City of Ramsey
Agenda
Environmental Policy Board (EPB)
Monday, January 23, 2023
6:30 pm
Council Chambers, 7550 Sunwood Drive NW

5. **Policy Board Business**
 1. Consider Natural Resource Aspects of Site Plan and Plat for AARA Dome (Project No. 22-123); Case of Anoka Ramsey Athletic Association
 2. Consider Natural Resources Related Elements for Parkside Townhomes Preliminary Plat

Consider Natural Resource Aspects of Site Plan and Plat for AARA Dome (Project No. 22-123); Case of Anoka Ramsey Athletic Association

The City has received an application from Ramsey at COR LLC (the "Applicant") for Preliminary Plat review of a proposed townhome development located on the block bordered by Rhinestone Street, Traprock Street, 146th Avenue, and Ramsey Parkway (the "Subject Property"). The purpose of this case is to review the Landscape Plan and other natural resources aspects of the project.

LANDSCAPE LAYOUT PLAN:

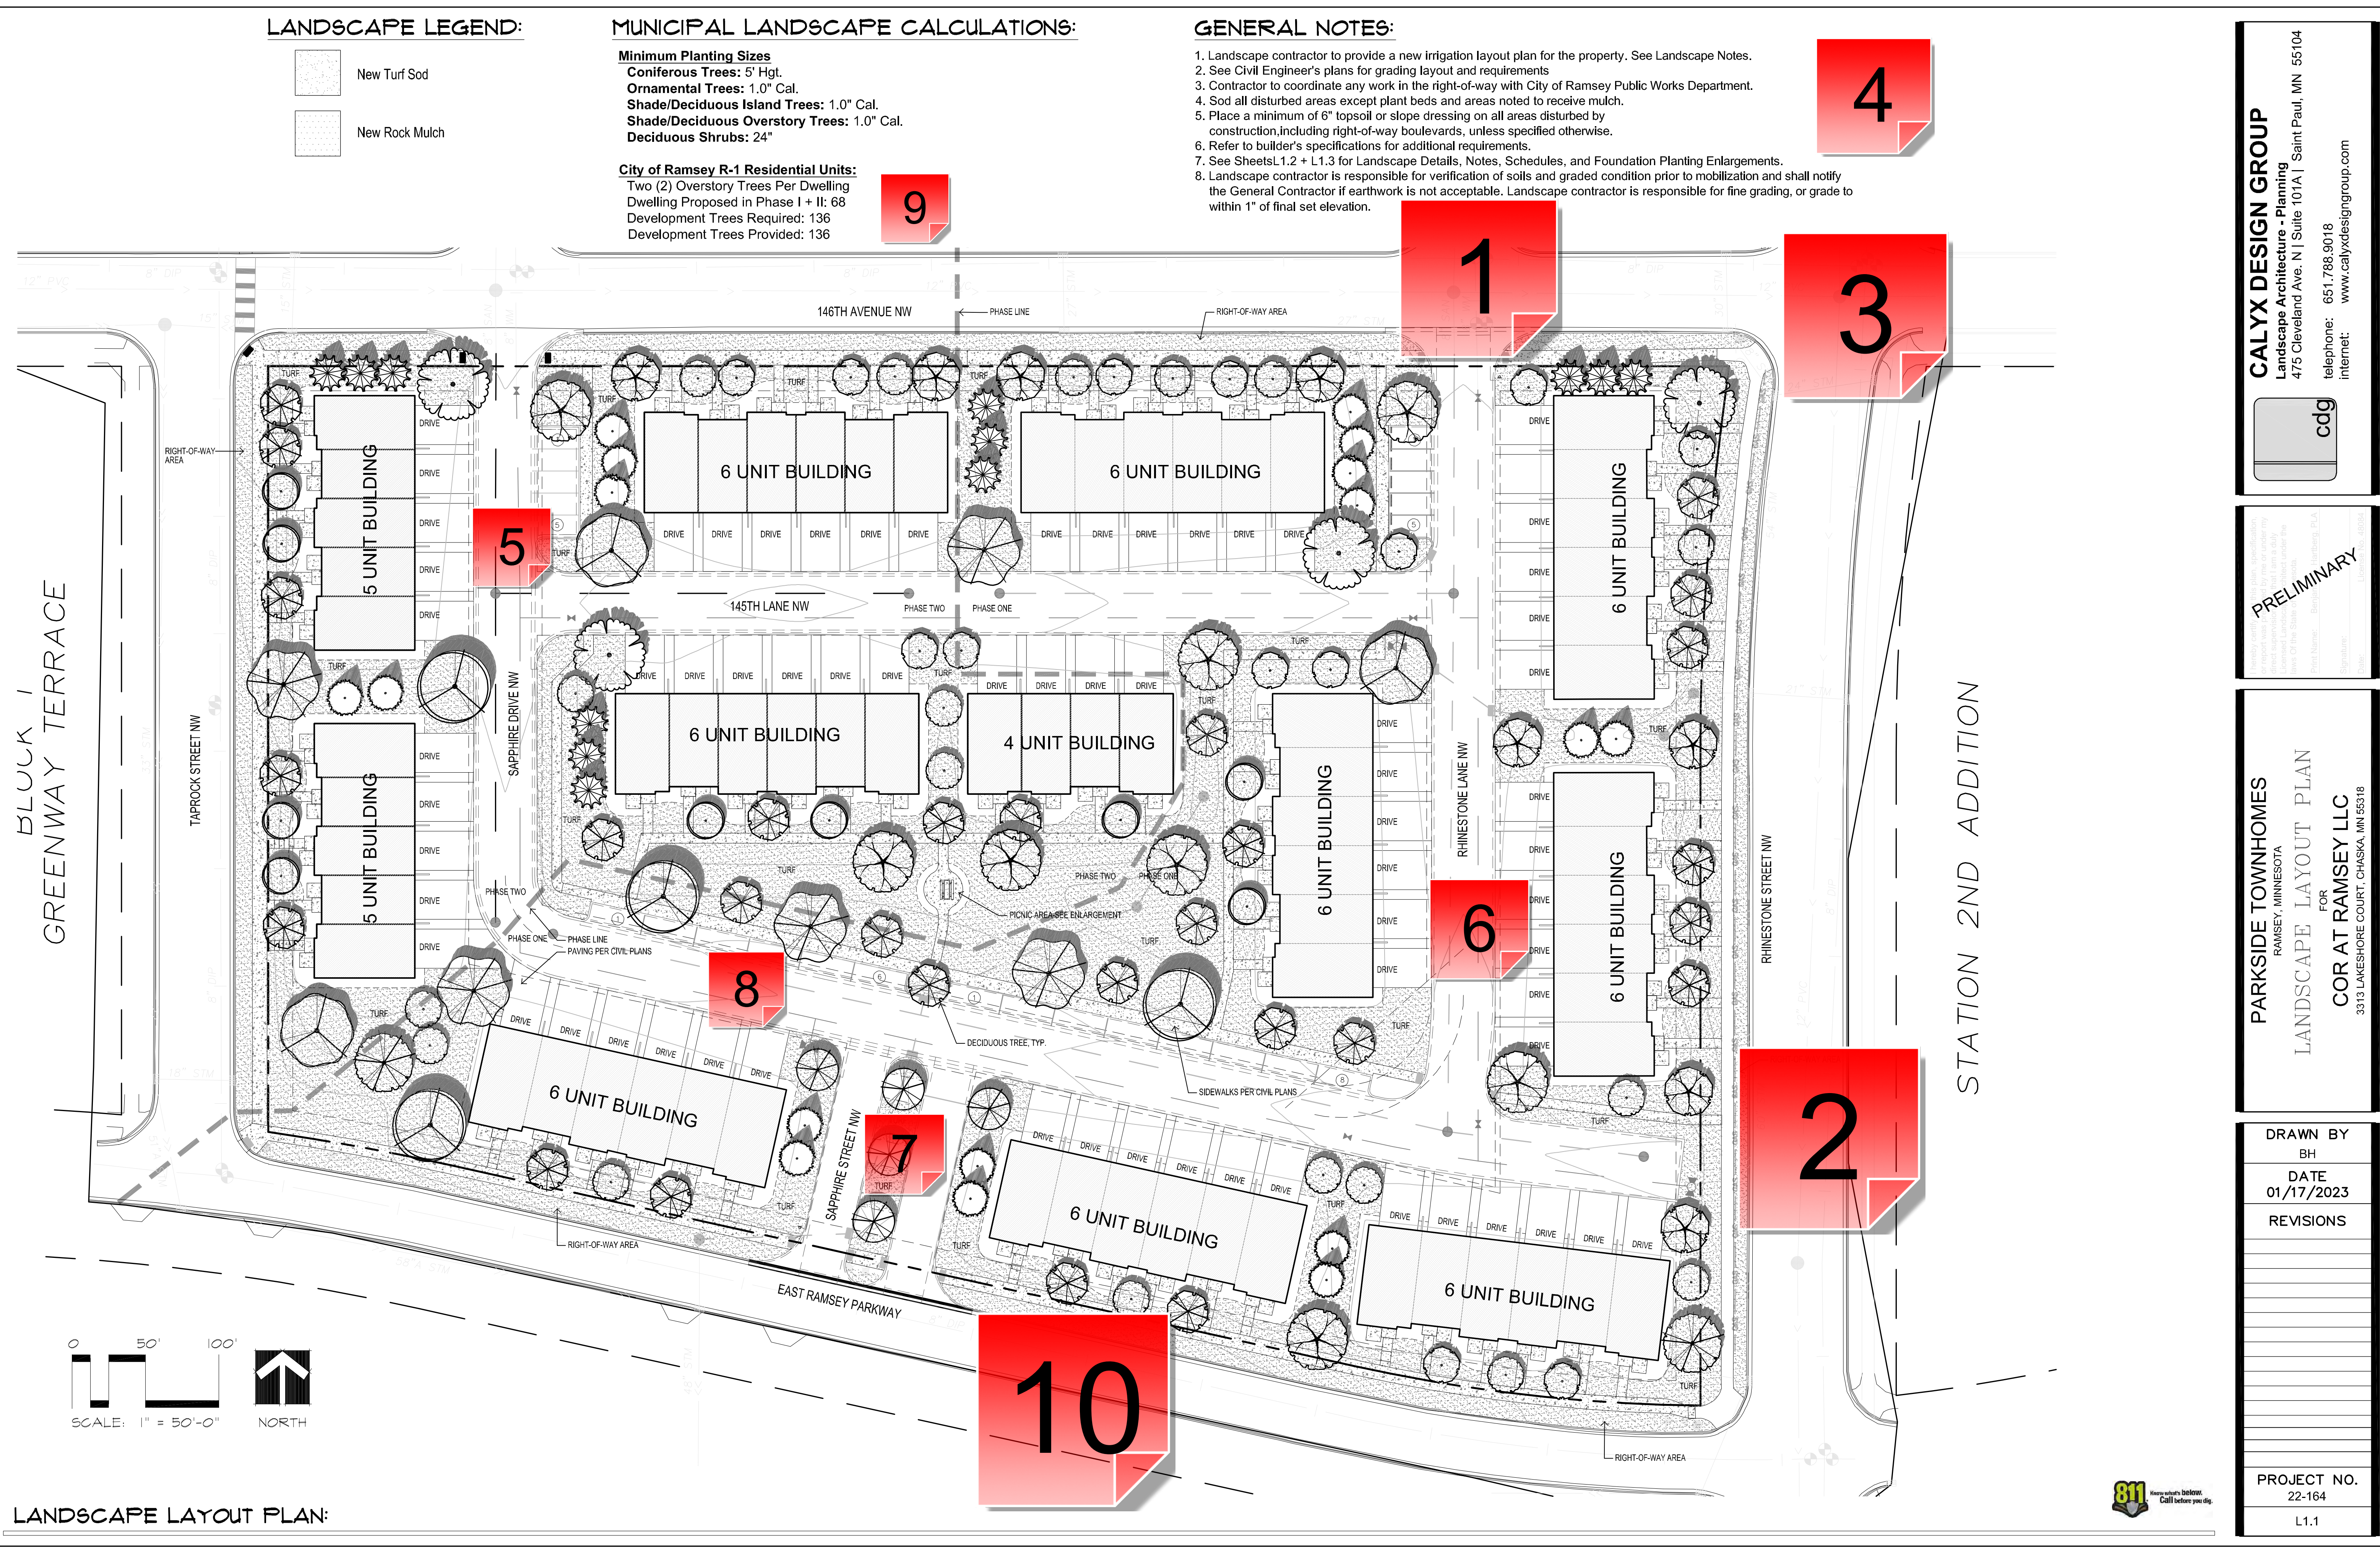
Add (or modify existing) note that all disturbed areas not otherwise improved with impervious surfacing shall have four (4) inches of topsoil, with not more than 35% sand content. Topsoil inspection is required PRIOR to installing sod and trees.

Add street name of 145th Place NW.

The R-1 planting standards are not applicable to this project. This project is more similar to R-3, you can refer to those standards here:

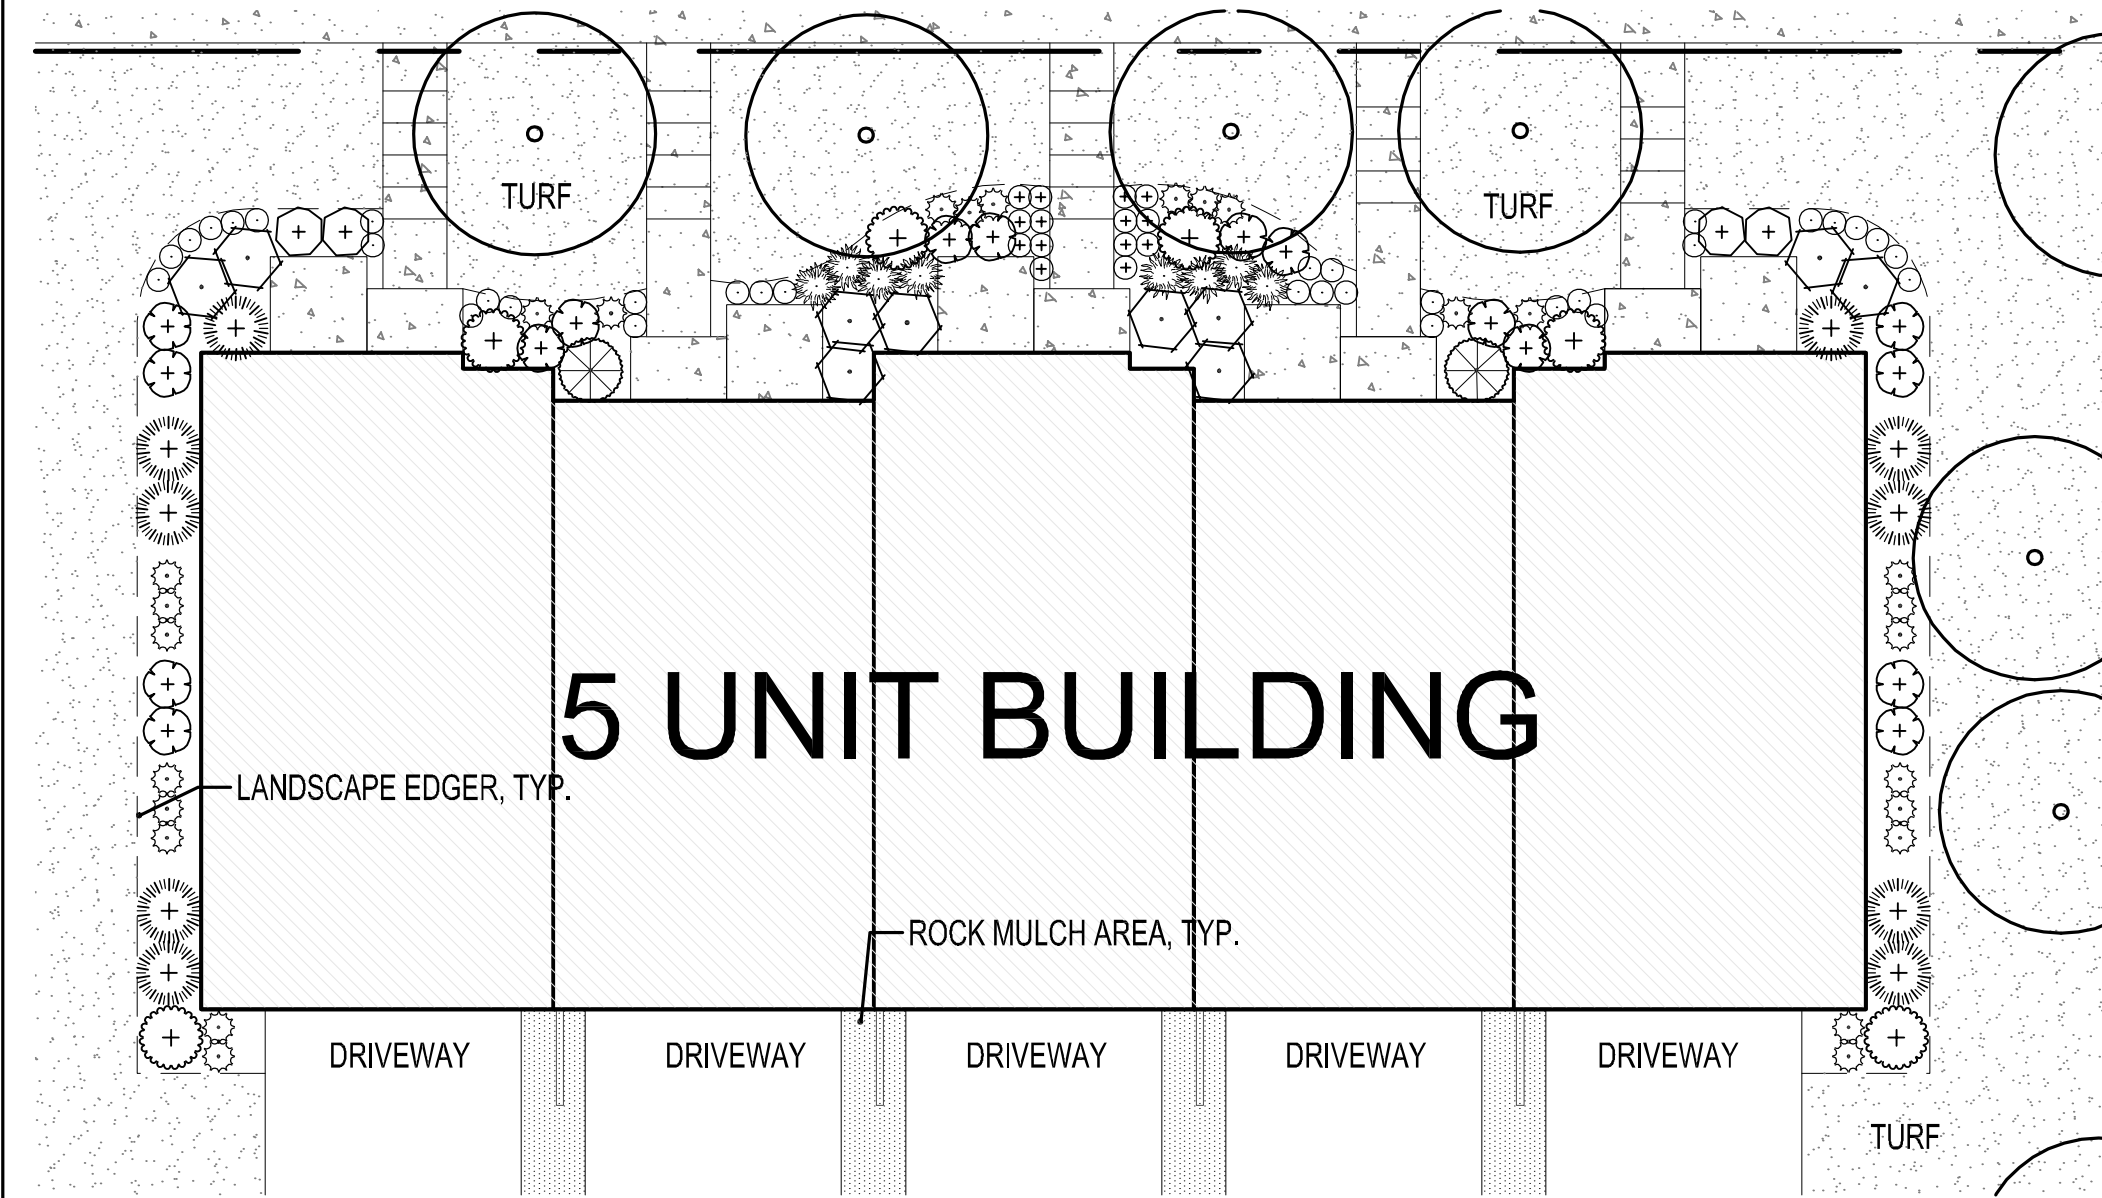
Per the Design Framework, street furniture, such as bike racks, trash receptacles, and benches are required along Parkway streets. City Staff would suggest that these be installed on the south side of Ramsey Parkway, adjacent to The Draw park, rather than in front of the 3, 6-unit buildings. Please coordinate with City Staff as there are specific models of each of the furniture sites that are acceptable.

DETAILS, NOTES, AND SCHEDULES:

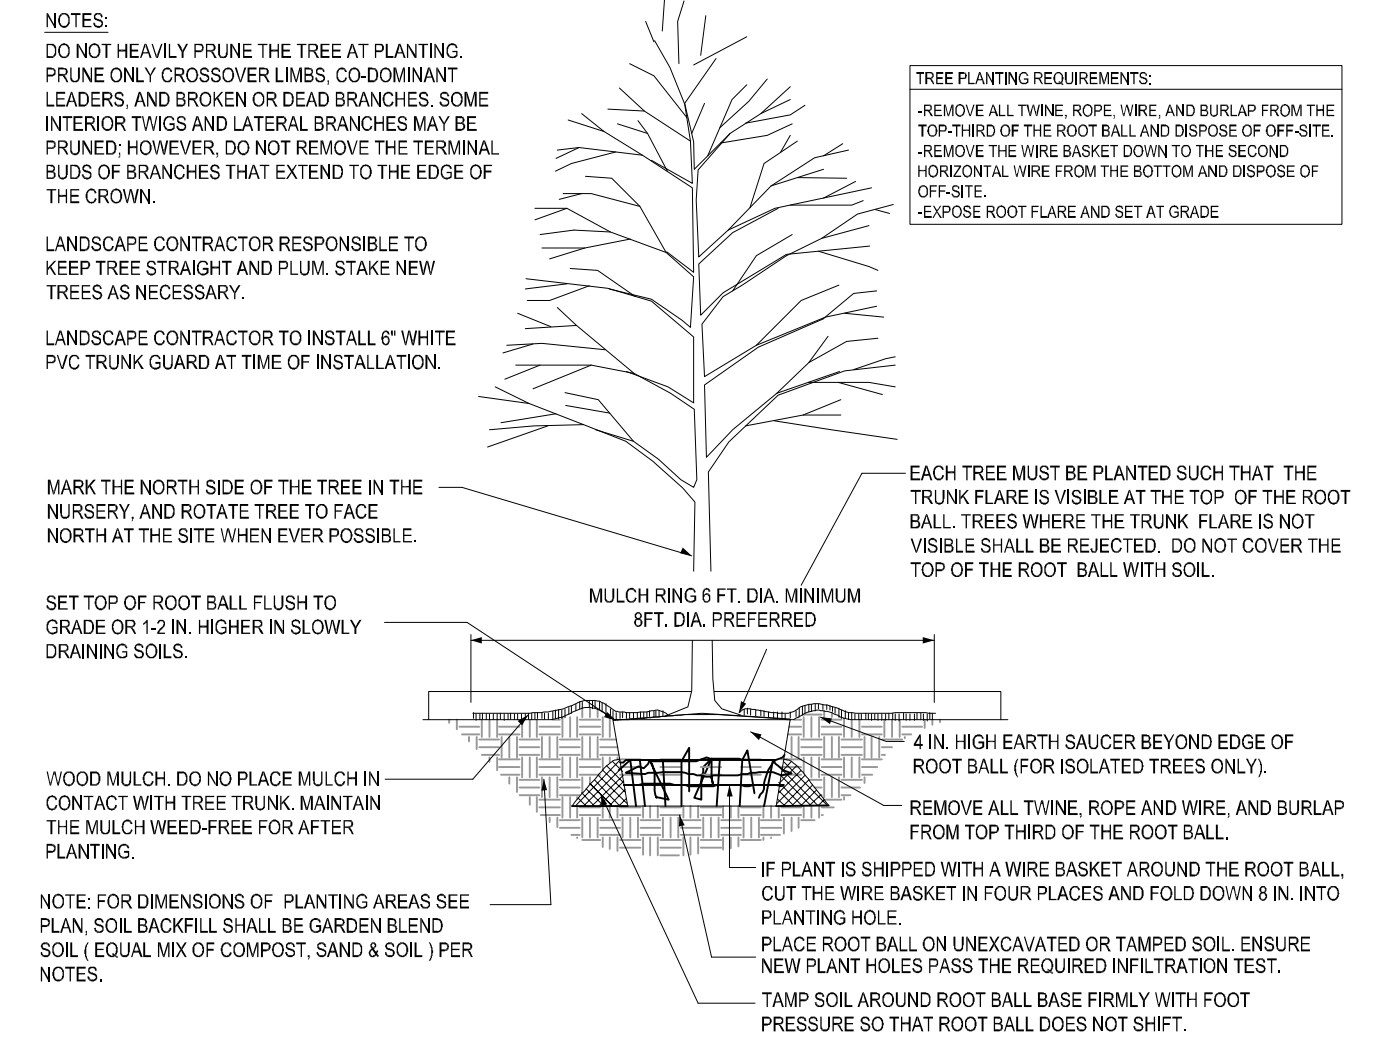
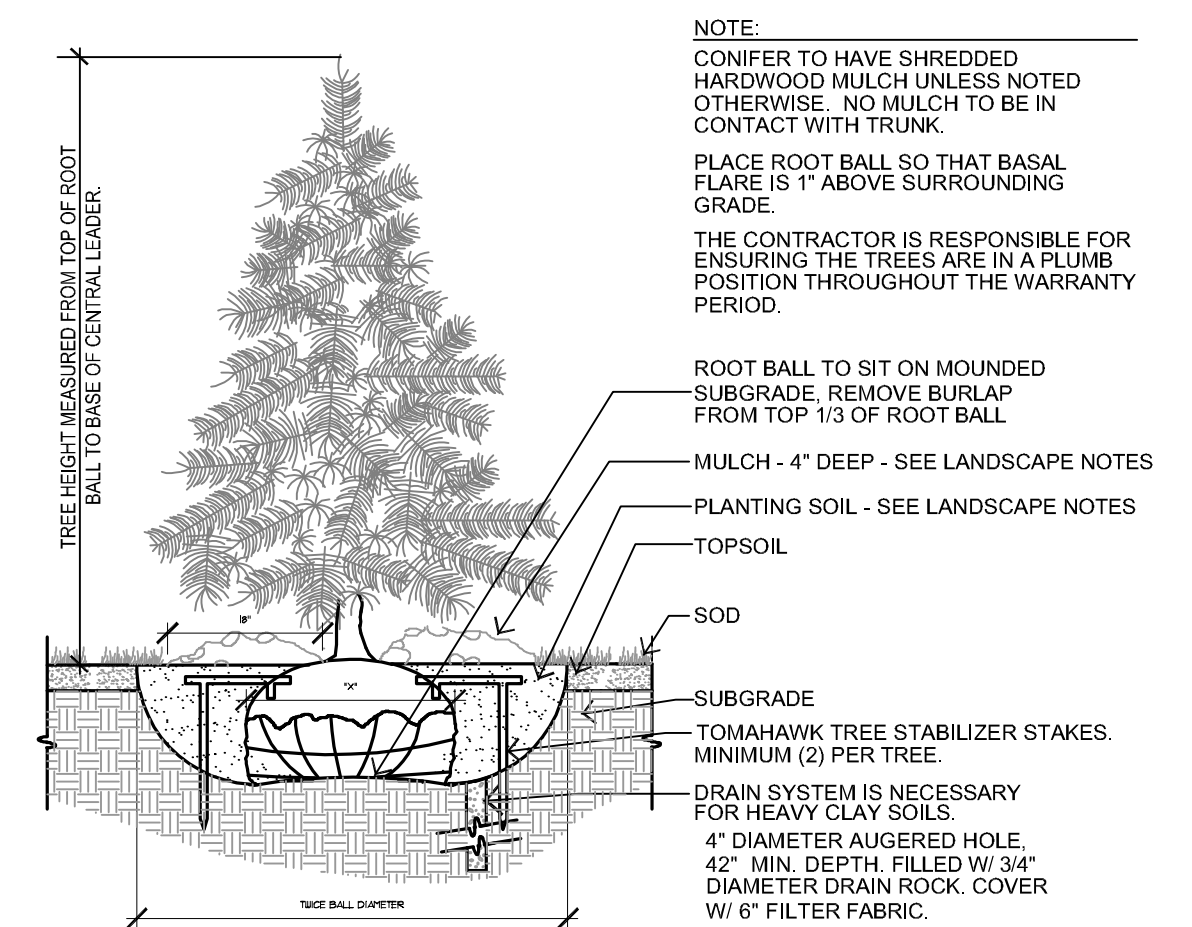
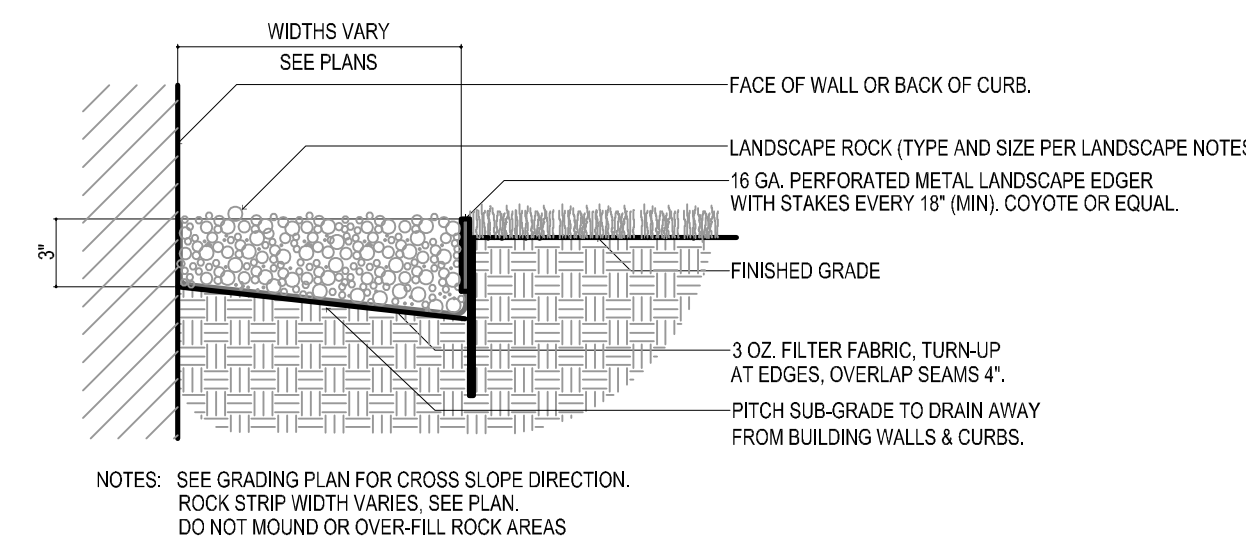
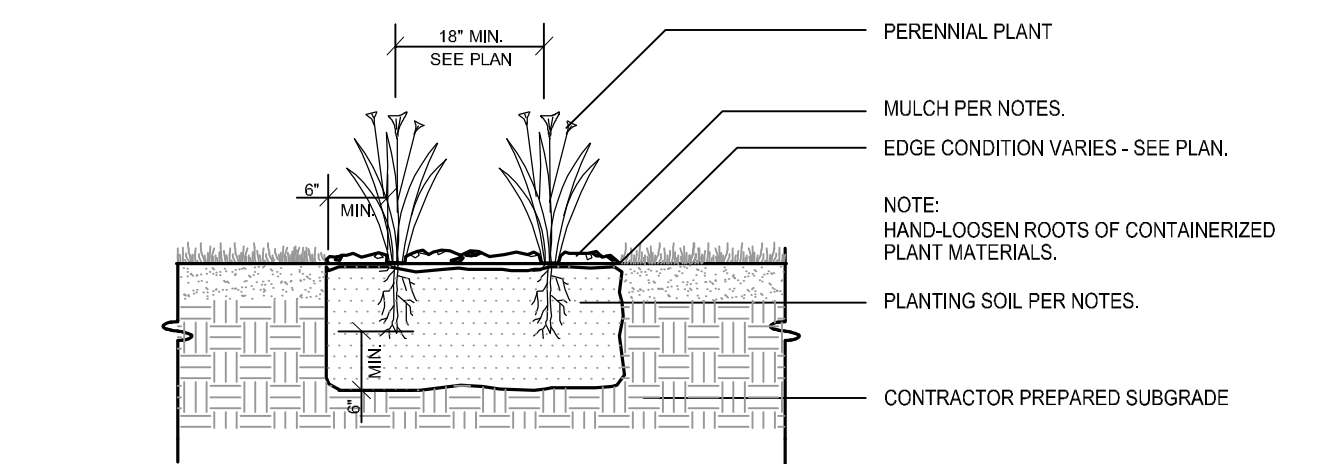
Modify Planting Schedule to specify that minimum size of shrubs at installation is 24 inches in height.

The required Development Agreement will specify that all plantings are subject to a two (2) year Maintenance Guarantee.

Add an Irrigation Note that specifies that the irrigation system must include a rain sensor AND water efficient technology, such as a smart controller.
